MONTANO PLAZA

EAST CORNER COORS ROAD AND MONTANO ROAD NW
ALBUQUERQUE, NEW MEXICO

SITE PLAN
 AUGUST 25, 1967 REVISION
 REVISED 6/1/06 - JL

34 April, 2014 - Administrative Amendment; applies to pad sites "D" only.

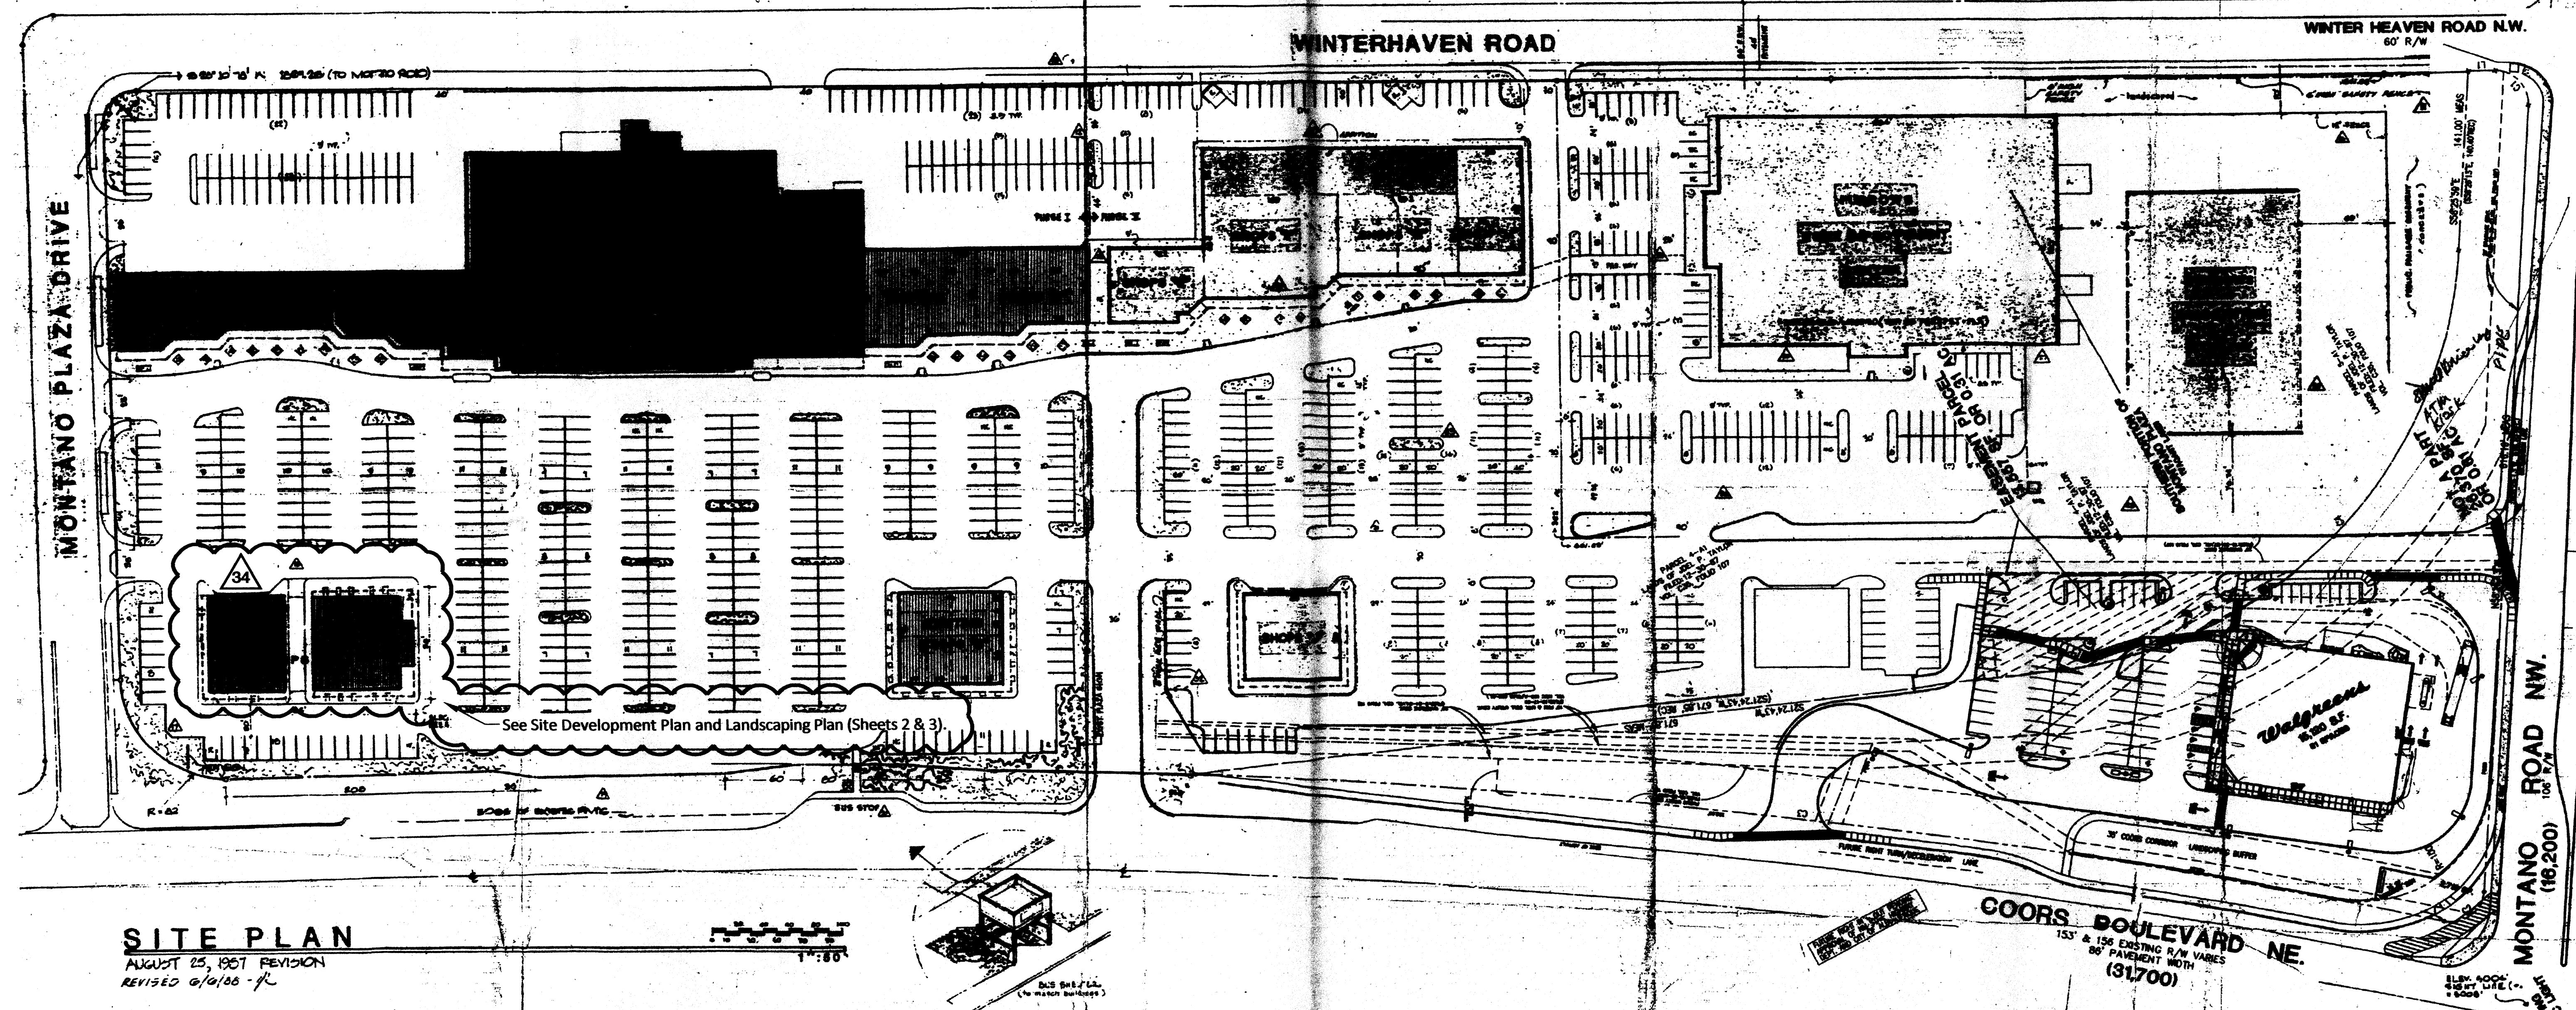
- Replaces 2 buildings at NW corner with proposed Applebees restaurant.
- Amends height restrictions to allow elevator tower, rooftop patio, and screening of rooftop equipment.
- Allows minor variation in color and architectural style.

REVISIONS PER EPC COMMENTS OF 2-18-17

- ▲ PARKING ADJUSTED TO ALLOW PEDESTRIAN LINK TO FURROWS
- ▲ SHOPS "E" ADJUSTED TO ALLOW PEDESTRIAN PASSAGEWAY
- ▲ PEDESTRIAN ACCESS TO WINTERHAVEN ROAD ADDED
- ▲ STREET IMPROVEMENTS AND LANDSCAPING TO BE CONSTRUCTED AT INSTRUCTION OF TRAFFIC ENGINEER
- ▲ END ISLANDS CHANGED TO 8' (TYP.)
- ▲ 30' BUFFER @ INTERCHANGE R.O.W. SHOWN; 30' INTERIOR ON INSIDE ONLY
- ▲ 12" FENCE TO BE SOLID WOOD, OPaque - 30' LUMP ALL PLANTERS
- ▲ DESIGNATED R.O.W. FOR TURN @ MONTANO PLAZA DRIVE SHOWN; PROPOSED SIGN RELOCATED
- ▲ PEDESTRIAN SIGNAGE PROVIDED BETWEEN BUILDINGS "E"
- ▲ SIDEWALK @ COORS TO BE CONSTRUCTED @ TRAFFIC ENGINEER'S REQUEST
- ▲ SHELTER AND BAY PROVIDED BY DEVELOPER
- ▲ PARKING SPACES SETBACKS TO BE FOR CONSTRUCTION @ END OF TURNING @ 20' MIN
- ▲ ADDITIONAL 5' ON EDGE PROVIDED FOR THIS DATE PER TRAFFIC ENGINEER'S REQUEST
